# HIDEOUT, UTAH PLANNING COMMISSION REGULAR MEETING (RESCHEDULED)

# Wildhorse Development Concept Plan – Updated

Staff Report/Presentation

# Elk Horn Springs Development Concept Plan – Updated

## Lot Configuration, Road Network and Topo

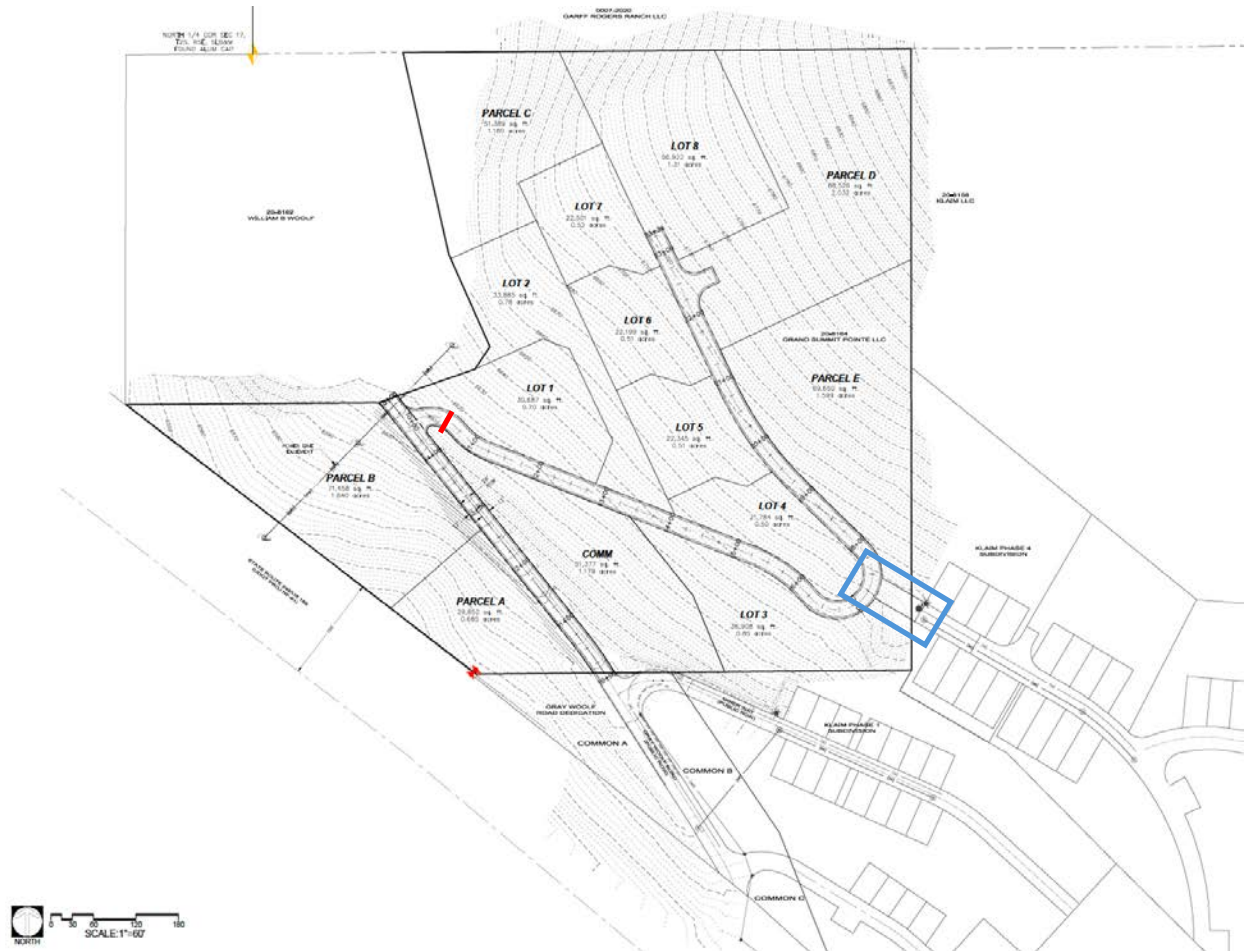
- 8 Single-family Lots
- 1 Neighborhood Commercial Lot moved from the west part of the site to the middle
- Need to include Limits of Disturbance (LOD) on the Lots and/or proposed setbacks
- Road reviewed by the Fire Department and generally given the thumbs up...with an emergency connection to KLAIM (indicated in blue)
- Gated community – gate located indicated in red

## Sensitive Lands & Steep Slopes

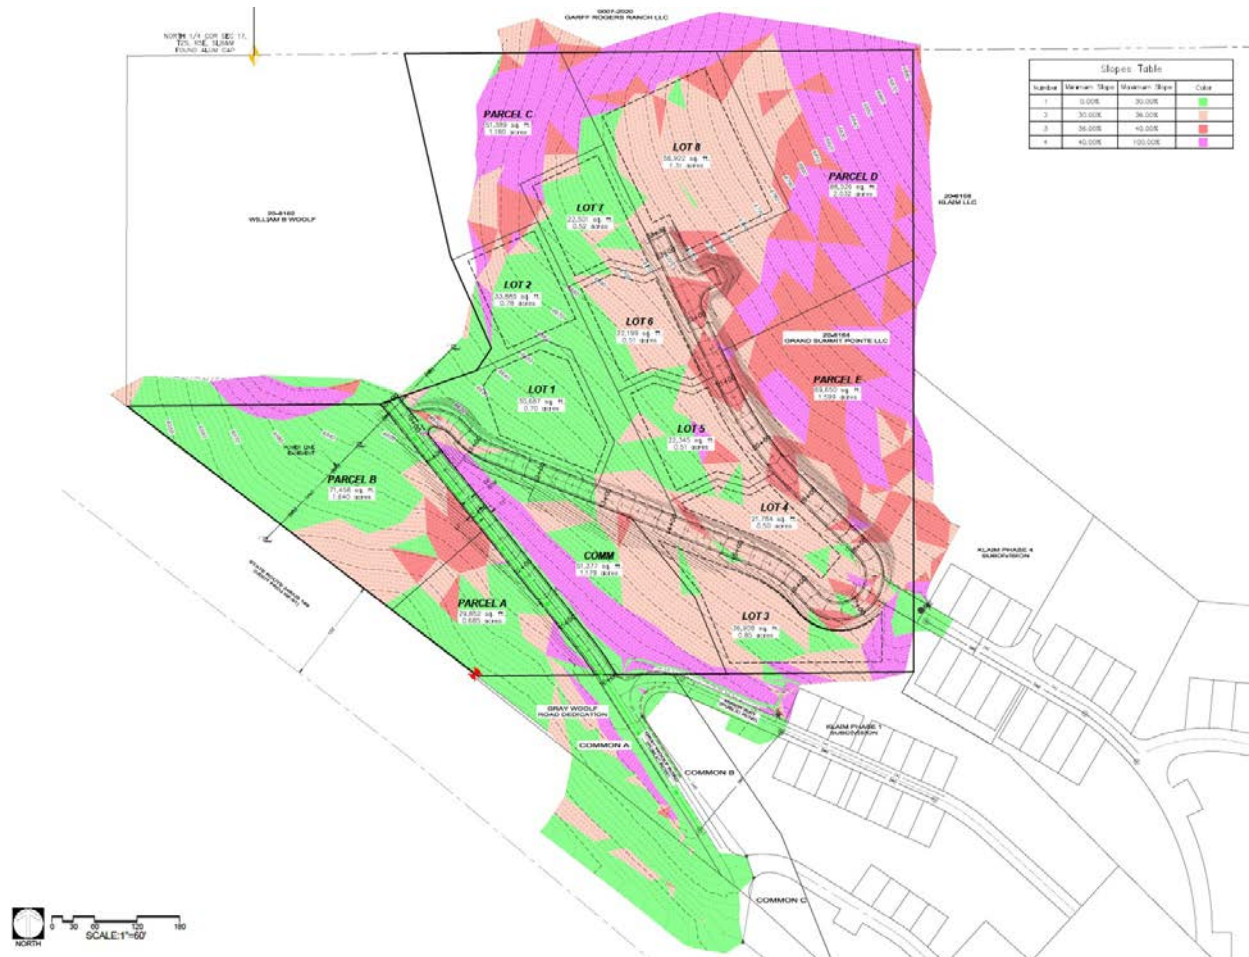
- Much of this site is greater than 30% slope. The areas identified in green are areas less than 30% slopes and considered buildable per the Sensitive Lands code language.
- The areas in salmon, red, purple represent slopes greater than 30% which are considered Sensitive Lands and unbuildable
- The Applicant has tried to stay off the steepest slopes and cluster the development towards the green area.
- Is the PC ok with development on steep slopes subject to a provision in an MDA allowing this proposed layout?

## Lot Configuration

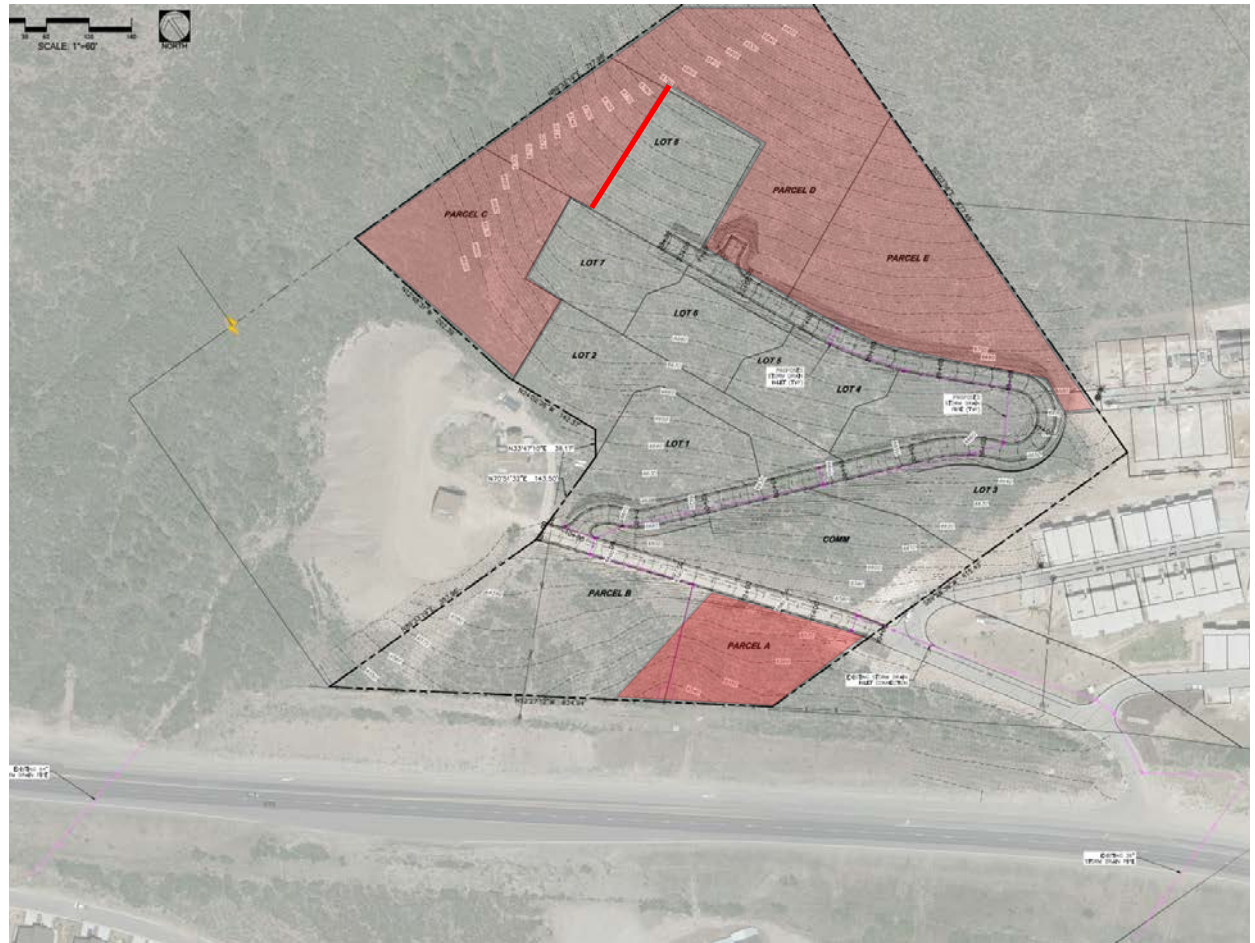
- Parcels A – E are steep slopes and dedicated as "open space" (shaded in red)
- Parcel B will be discussed with the Planning Commissioners in a subsequent slide as a possible 3 – 5 unit "villa" site
- Clustering necessitates a buffer around the site; Lot 8 will need to be reduced in size to ensure an "open space" setback for the total project site.

## Entry to the Commercial Building

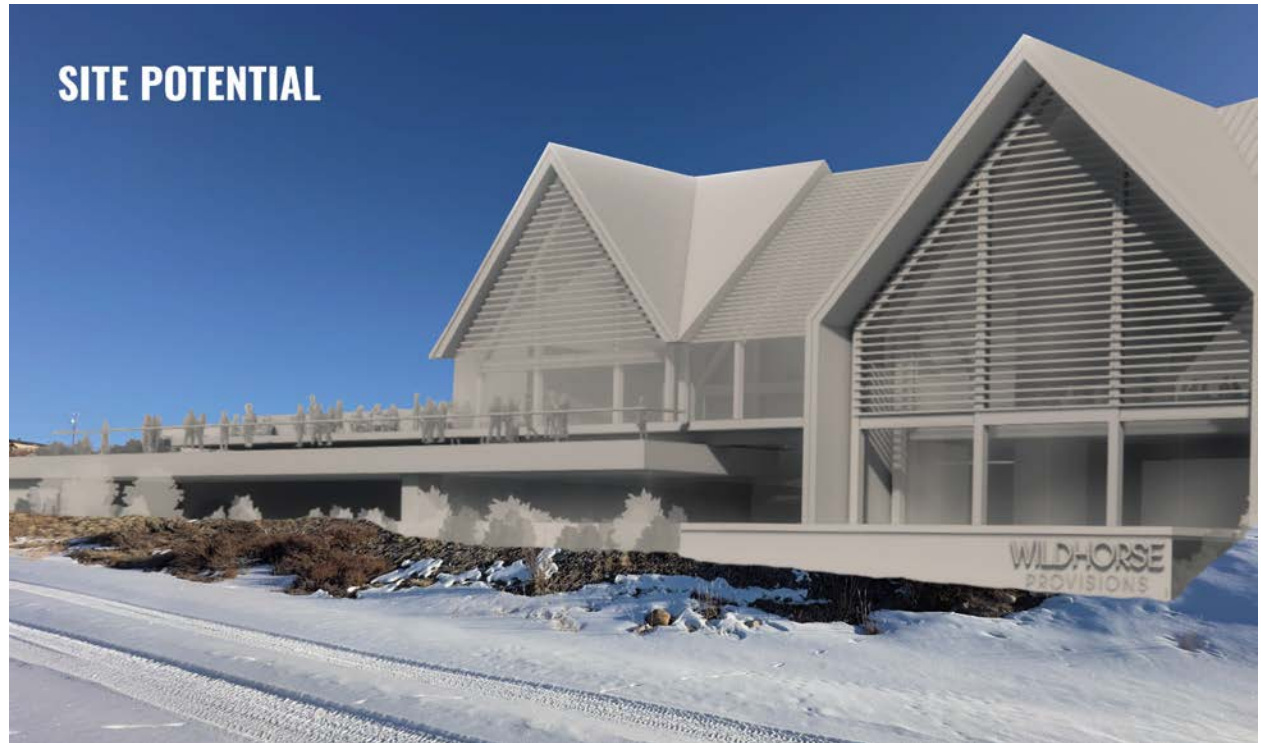
- Reduced retaining wall heights at entrance and less visible from the SR248 ROW
- Outdoor space set back much further from the SR248 ROW
- Maximum building heights to be included in the MDA subject to Concept Site Plan Review

## Commercial Site in Context

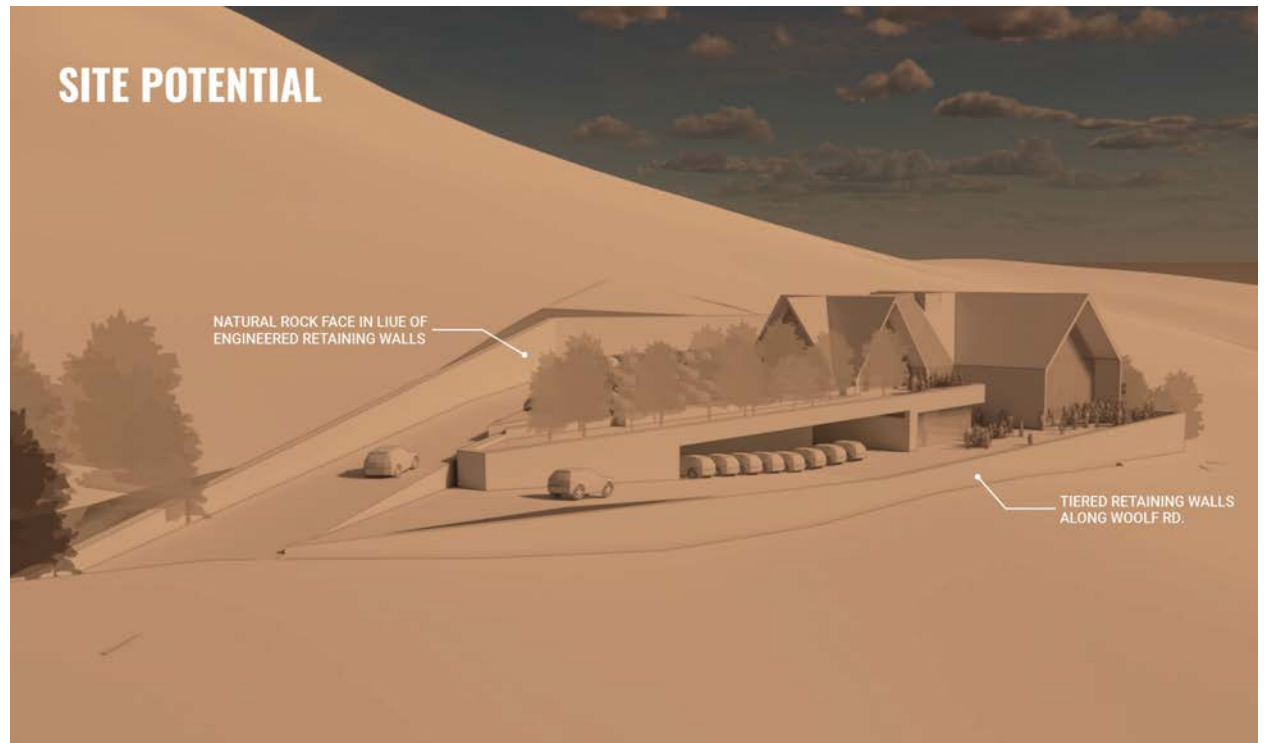
- 18'-0" retaining wall located behind the commercial building – screened from view
- Need to ensure the parking area (and retaining walls) will be screened by trees – confirm the parking structure will have deep tree wells to ensure survival
- The entry driveway should be rounded to ensure ease of access for visitors and fire and safety vehicles

## Commercial Site in Context

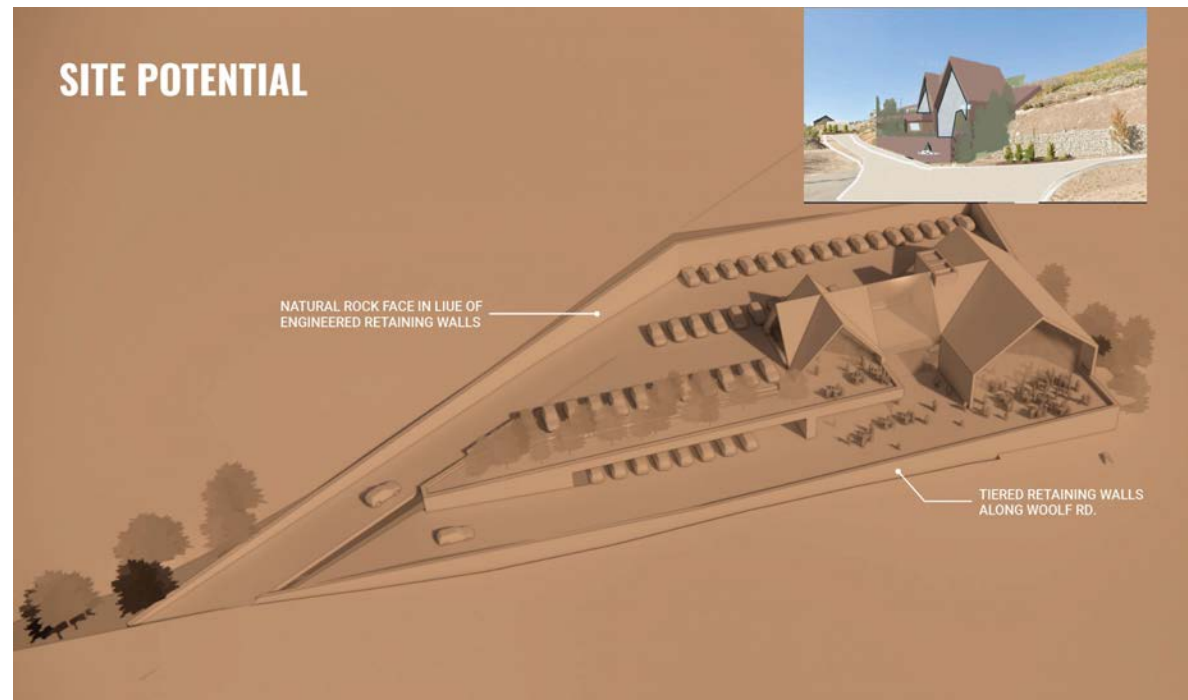
- Revise the entry way to a more perpendicular intersection at Woolf Road
- Stormwater retention on site for the commercial development must be designed and analyzed
- What is the width of the planter strip and separation from Woolf Road?

## Commercial Site in Context

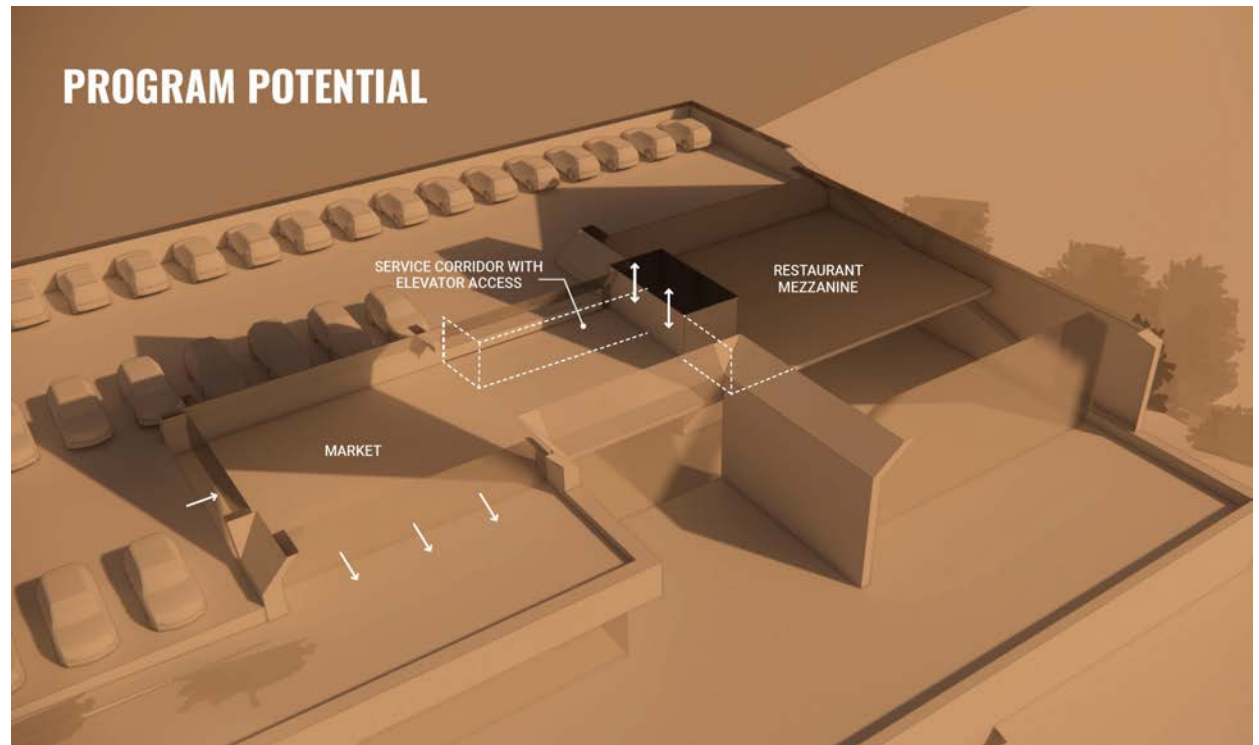
- Applicants to walk the PC through the proposed programming of the building

### SITE SECTION A

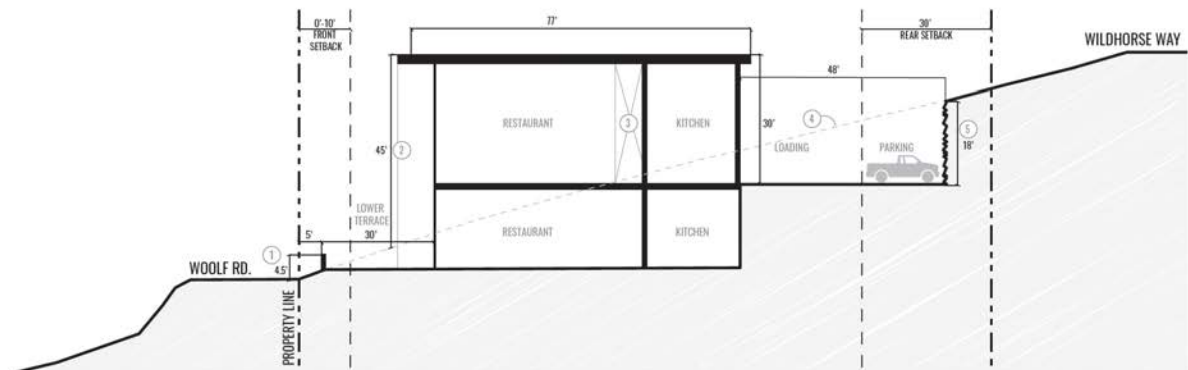
- Is PC comfortable with an 18--0" high retaining wall at the back of the parking lot? This would be an exception to the Zoning Code that would be included in an MDA

## Setbacks and Limits of Disturbance

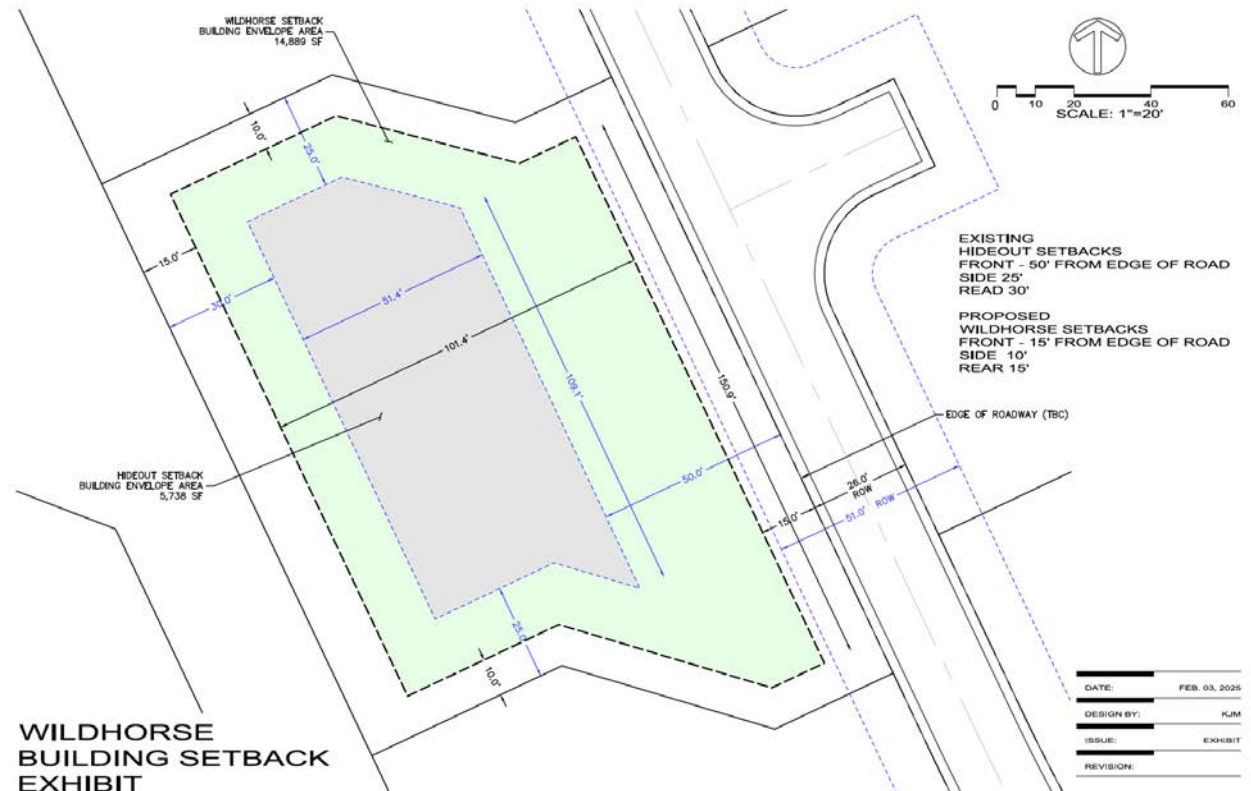
- The Mountain (M) residential zone has the following setback requirements:
  - Front: 50'
  - Sides: 25'
  - Rear: 30'
- The proposed site plan requests a reduction in setbacks as follows:
  - Front: 15'
  - Sides: 10'
  - Rear: 15'
- Based on prior discussions with the PC, staff recommends the following:
  - Front: 15'
  - Sides: 20'
  - Rear: 20'
- This ensures the preservation of native vegetation between houses

## Roads to the Houses

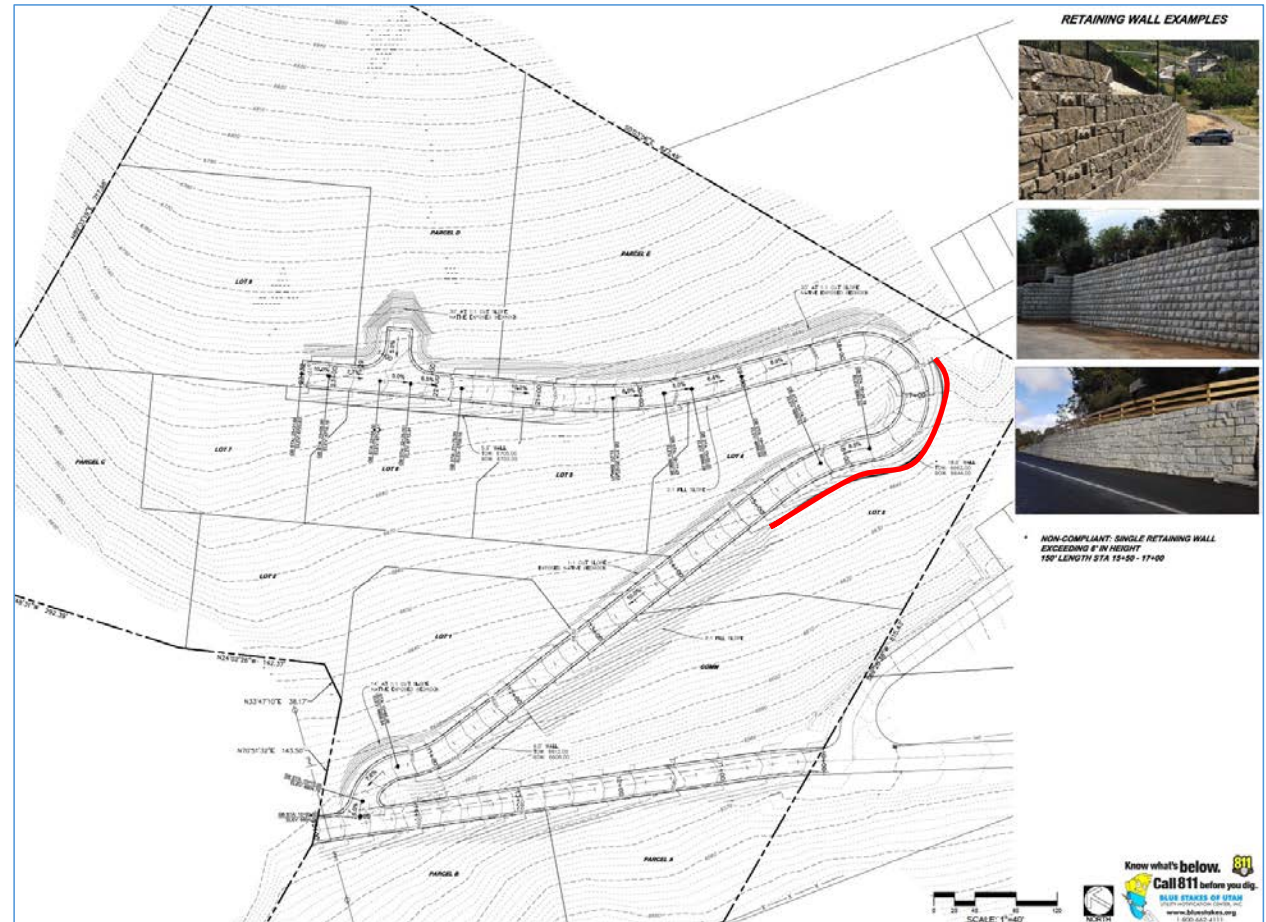
- The retaining wall supporting the road in red will be 20'-0" tall and, if approved, would be an exception to the Town Code included in the MDA
- Is the proposed material a Verti-block wall? A wall that looks like natural stacked stone is required. Staff recognizes that a natural stacked wall will not work in this location. Therefore, a structural wall that mimics a natural stone should be constructed subject to PC approval
